**ADDENDUM NO. 1**  
**TENDER NO. 138-24**  
**DERWENT PARK CRICKET FIELD**

**January 15, 2025**

# CONTRACT DRAWINGS FOR DERWENT PARK CRICKET FIELD CITY OF WINDSOR

**D7**  
**4 4** **DETAIL PLAN: PLAYER SEATING BASEPAD**  
SCALE: 1:100

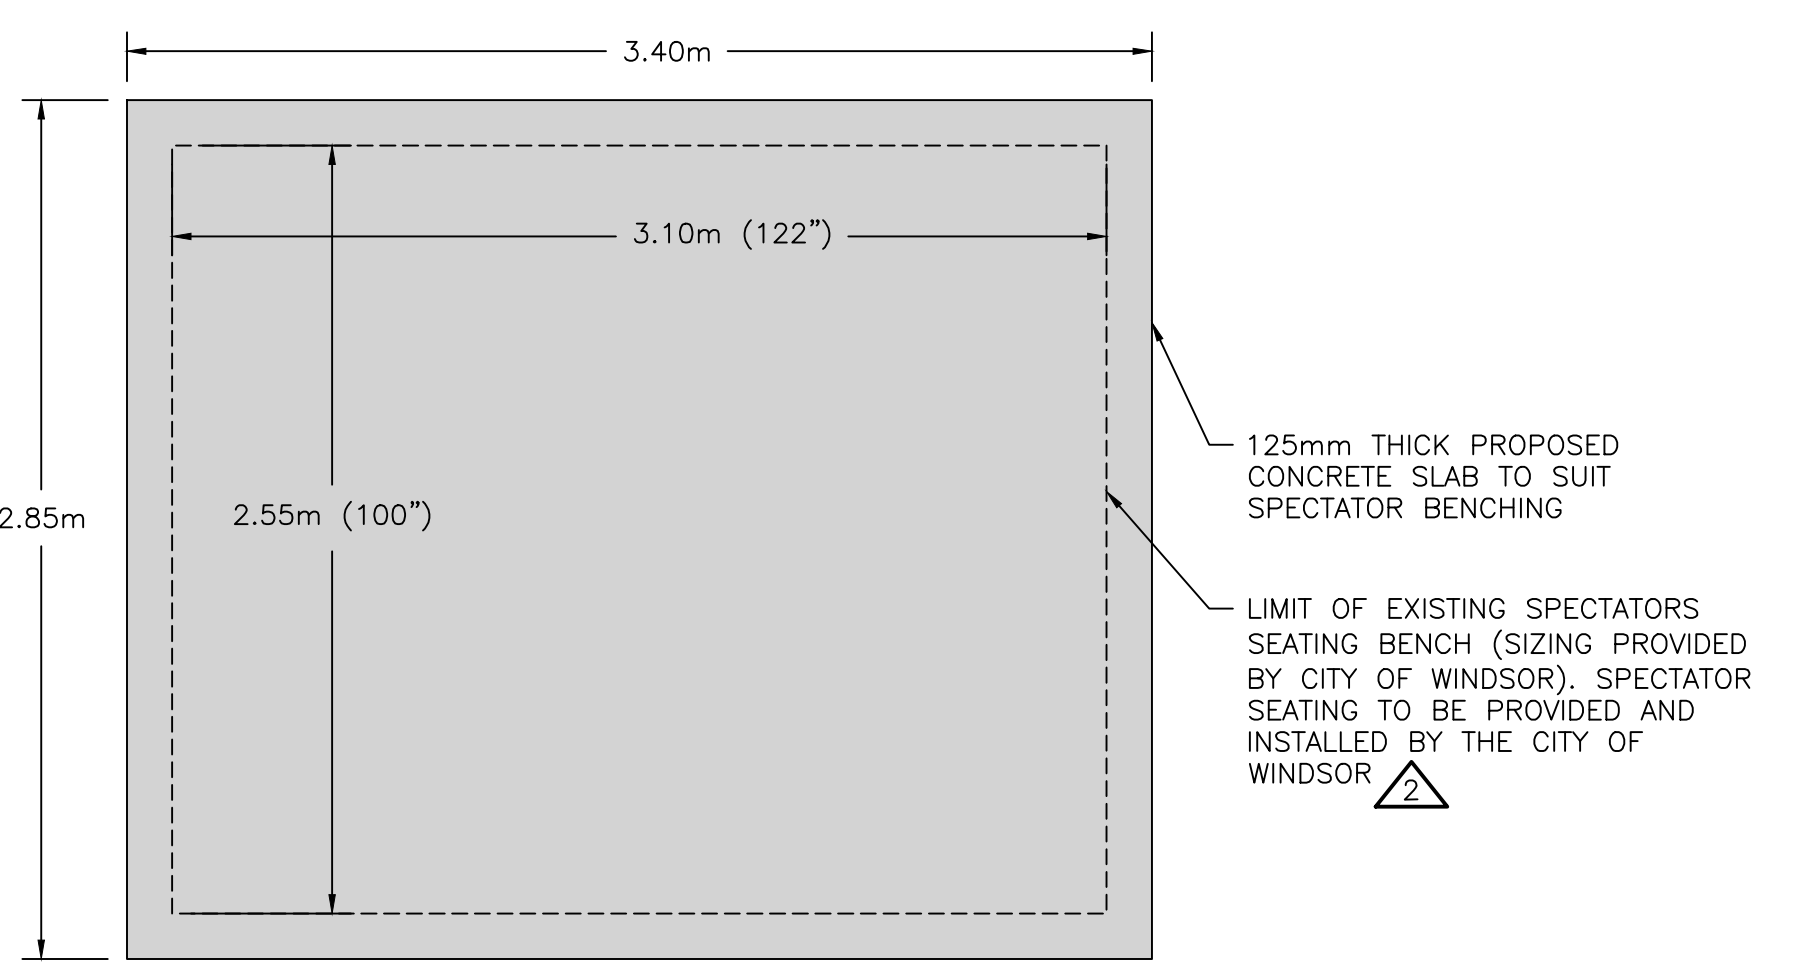
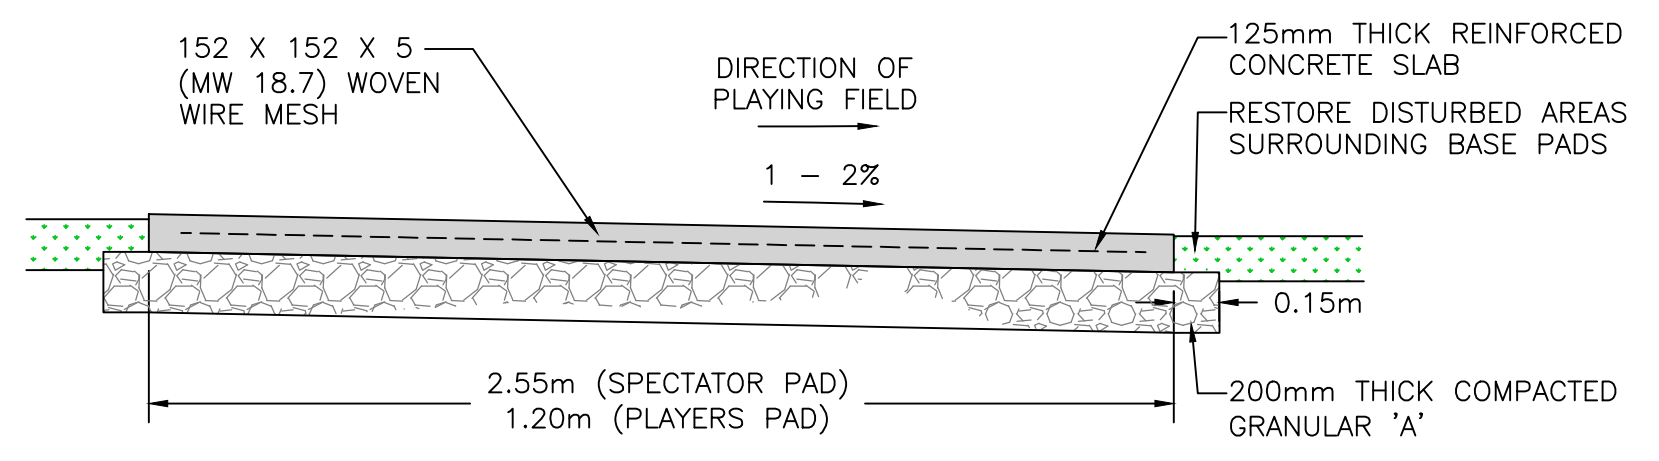
**8. Does the EuroShed get constructed on a concrete base?**

The EuroShed shall be constructed on a concrete base. The details for the concrete pad have been amended and are depicted on sheet 22-040-03

project no.	22-040
drawing no.	22-040-06
sheet no.	6 of 7
scale	AS SHOWN

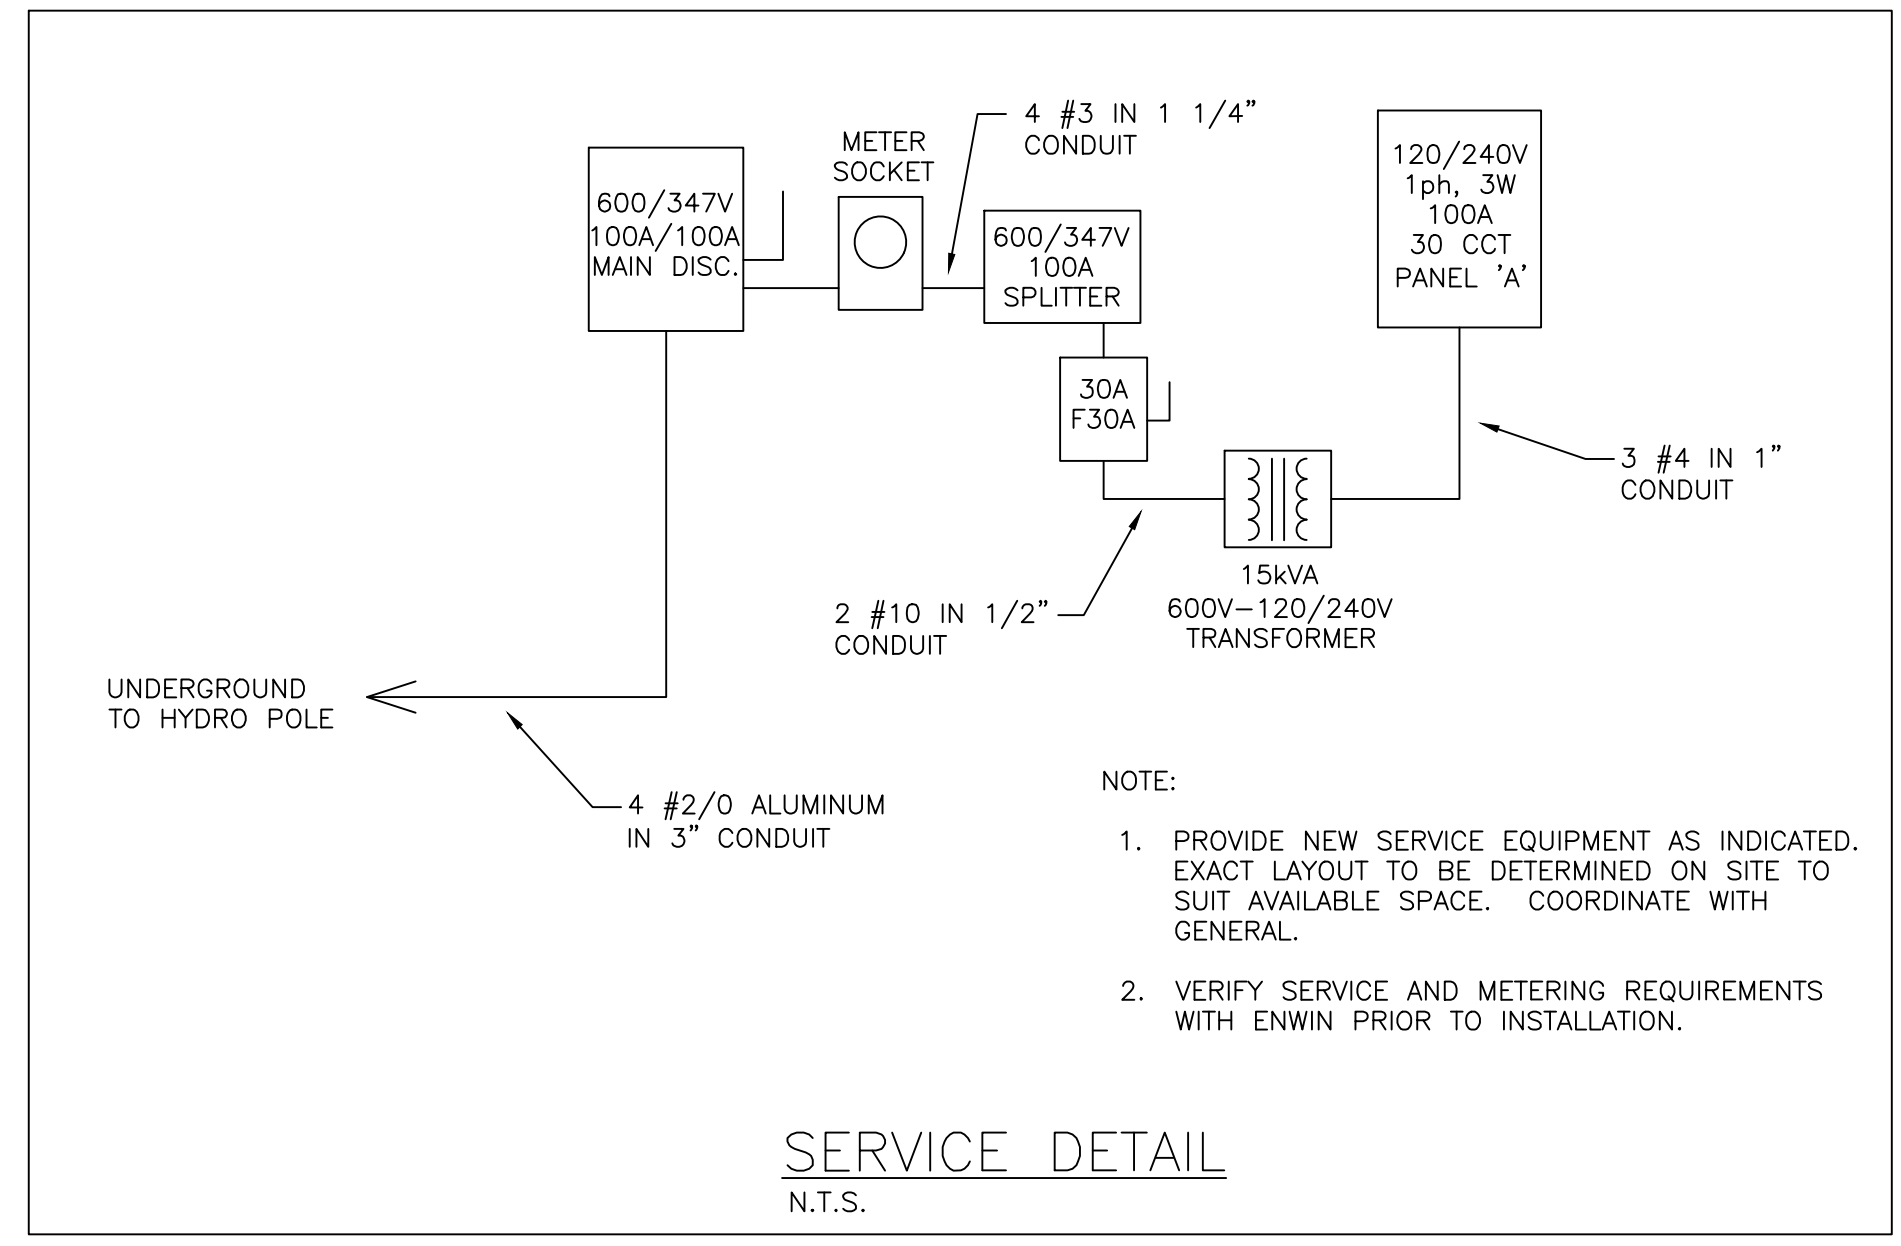
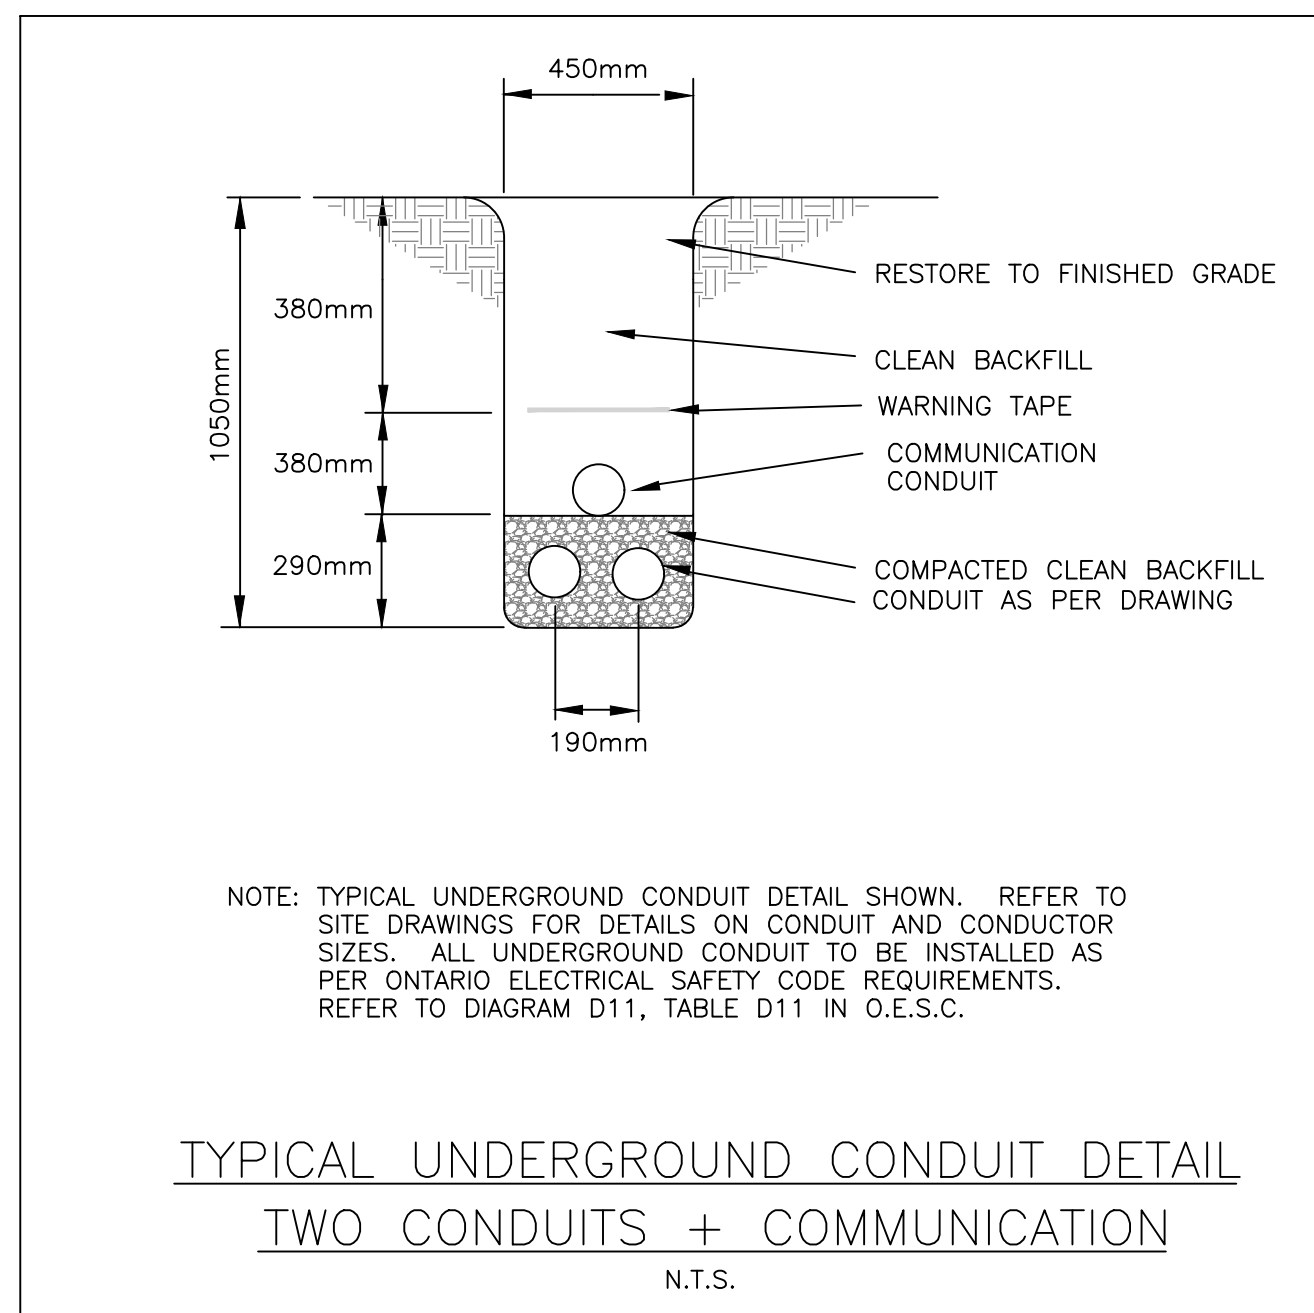
- a. Detail D4, Drawing Sheet 2, states, "Refer to diagram D11, Table D11 in OESC." Please provide.
- b. What grade of stainless (304 or 316), what gauge/thickness of material, is there more than one? It appears to be cast in place, are any holes or tabs needed to hold it in place. Could a sketch be included of what you think we might need.

The Contractor shall note that new Electrical Drawings have been issued.

- **22-040-06 Proposed Electrical Works** is attached hereto
- **22-040-07 Electrical Notes** is attached hereto

Title	ARTIFICIAL TURF / STUMP BOX DETAIL		Date	JANUARY 2025	FIGURE <b>1</b>
	Project	DERWENT PARK		Scale	
		Project No.	22-040

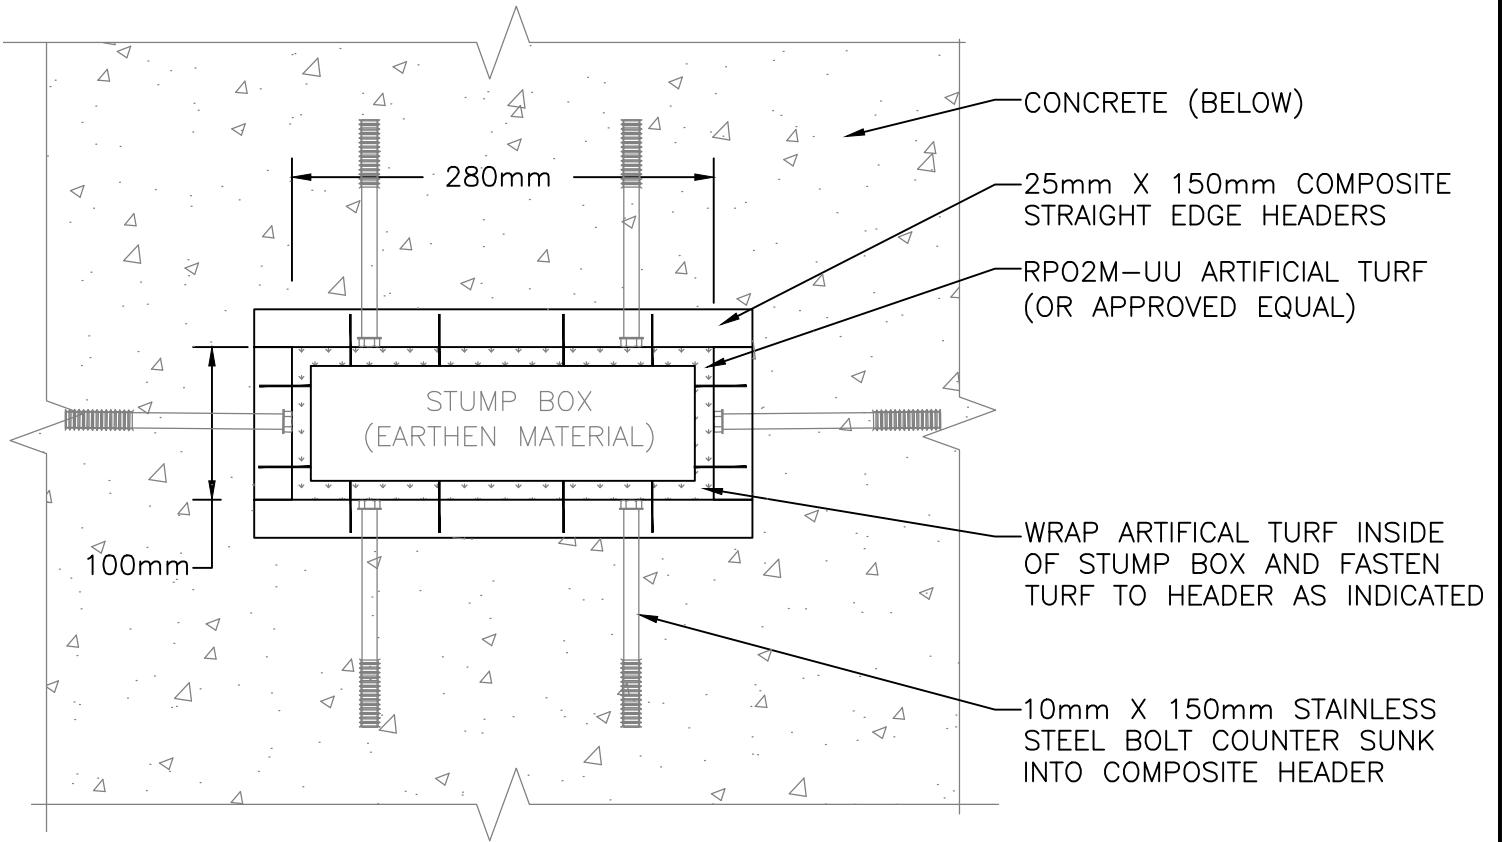
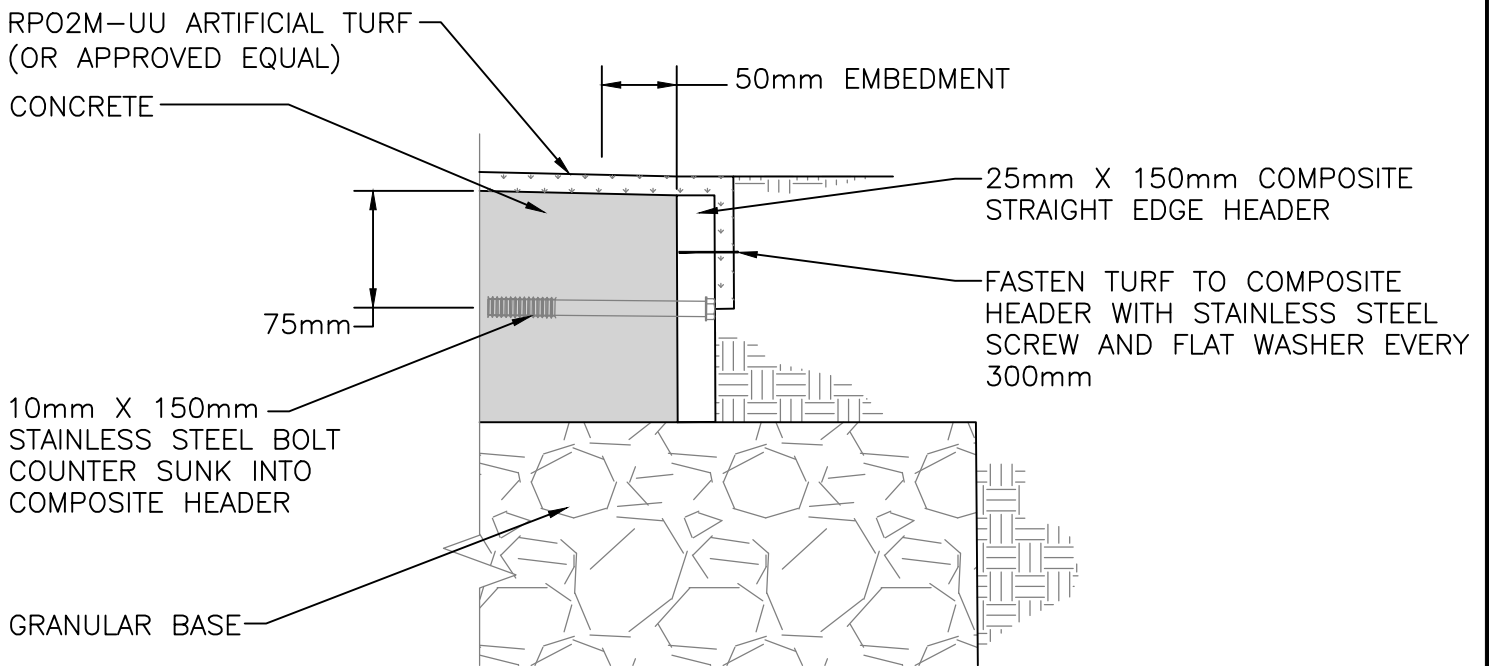
### 7. We are looking for details regarding the stainless stump box.

The stainless-steel stump box will be replaced with a composite wood stump box. See Figure 1, attached, for details related to stump box construction and artificial turf fastening.

FIGURE  
**2**

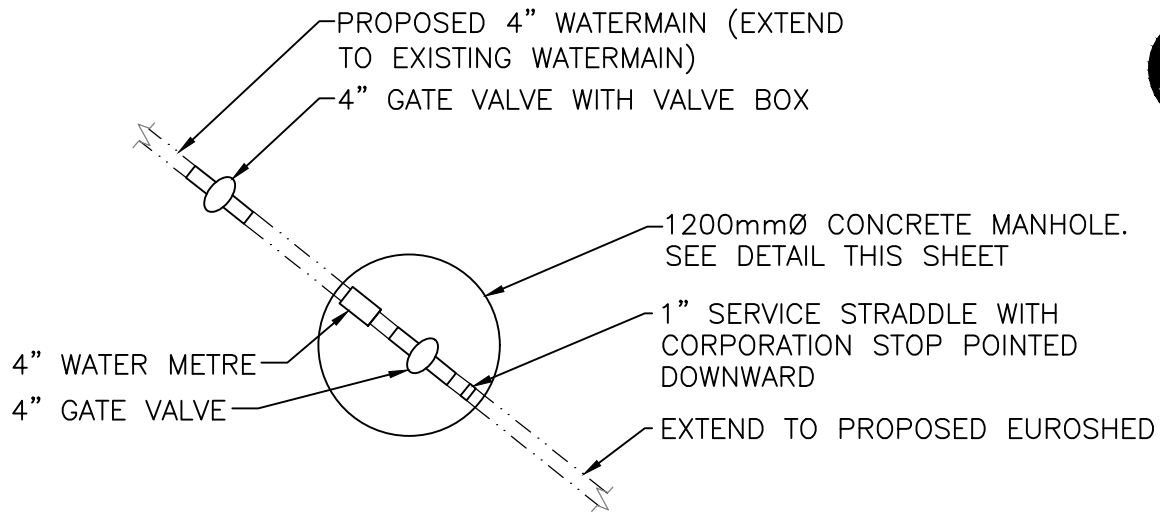
- a. They are asking for a 3" waterline PVC (On the documents it indicates 3" water). 3" is an odd size for watermain. we usually go 2" or 4". Can you please confirm which size is required; what I gather from the prints is it is feeding a shed with a water supply. can we please get clarified
- b. It also asks for a 6" self draining corp stop? Please clarify.

- a. The Contractor shall use 4" PVC waterline in place of 3" PVC waterline to create the connection from the existing watermain to the proposed EuroShed.
- b. Windsor Utilities Commission has been contacted to obtain their preference for connecting and terminating the proposed water line. The attached drawings represent their preference for completion of the watermain works. Figure 2 attached provides details pertaining to a water service manhole that will be installed immediately upstream of the EuroShed.
